Solution Hose Upgrade/Repair Kit

Models: Tennant R14 / Nobles Strive Rider

This kit is intended for machines manufactured before serial number 10309496 DC1206 (Dec 29, 2006). The purpose of this kit is to repair and/or eliminate the risk of solution hose failure where the solution hose connects to the solution tank hose fitting.

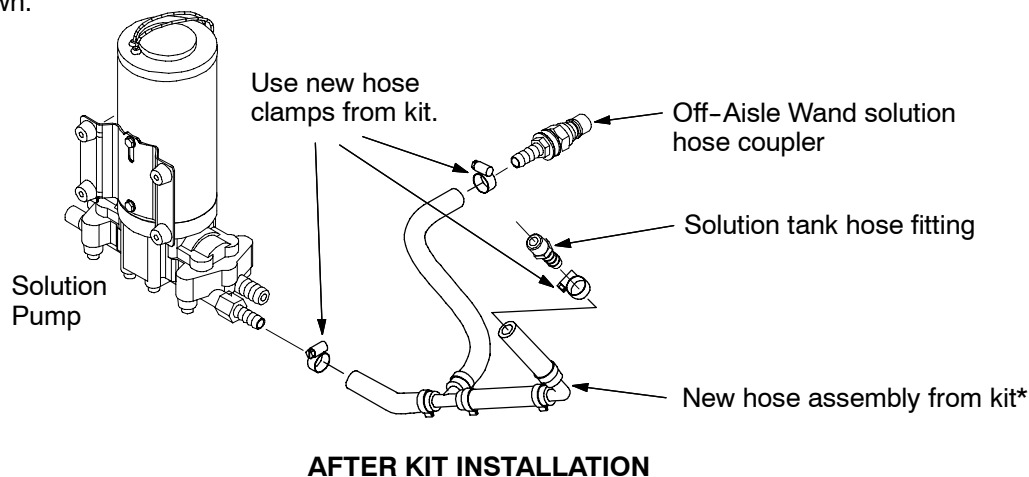
STEP 1: Remove and discard the outlined parts.

STEP 2: Install kit parts as shown.

*** NOTE:** Route the new hose assembly under the ReadySpace vacuum hose and clear solution hose.
